## 1968 - 1970 Corvette: Service Bulletin: Depressed Park Windshield Wipers Unable to Park

Model and Year: 1968 - 1970 Corvette

**Bulletin No:** 70-T-59

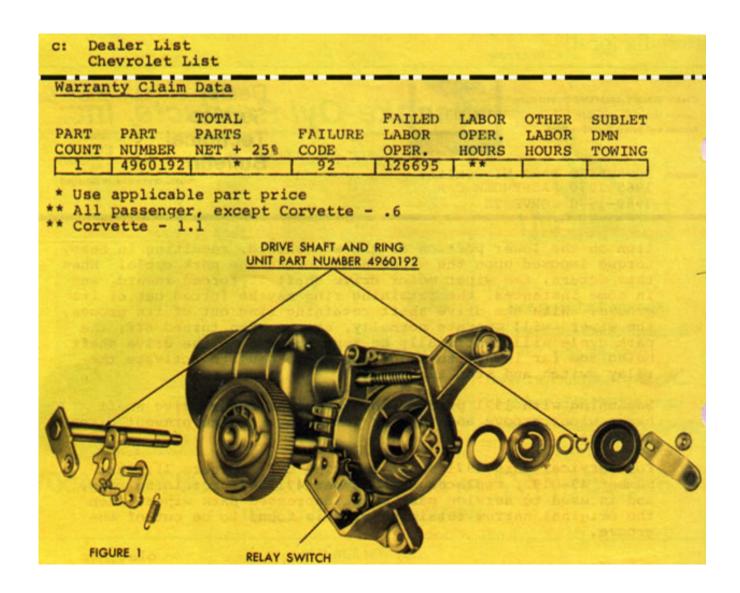
This problem usually is a result of heavy snow or ice accumulation on the lower portion of the windshield, resulting in heavy torque imposed upon the wiper arms during the park cycle. When this occurs, the wiper motor drive shaft is forced inward, and in some instances, the retaining ring may be forced out of its groove. With the drive shaft retaining ring out of its groove, the wipers will operate normally, except when turned off, the park cycle will continually be repeated due to the drive shaft being too far inward to allow the drive pawl to activate the relay switch and stop the motor.

Beginning with 1971 production, the wiper motor drive shaft has a wider groove and thicker retaining ring to prevent disengagement.

For service, this 1971 shaft and ring unit (Figure 1), Part Number 4960192, replaces Part Number 4911264, retaining ring, and is used to service past model depressed park wipers when the original narrow retaining ring is found to be out of the groove.
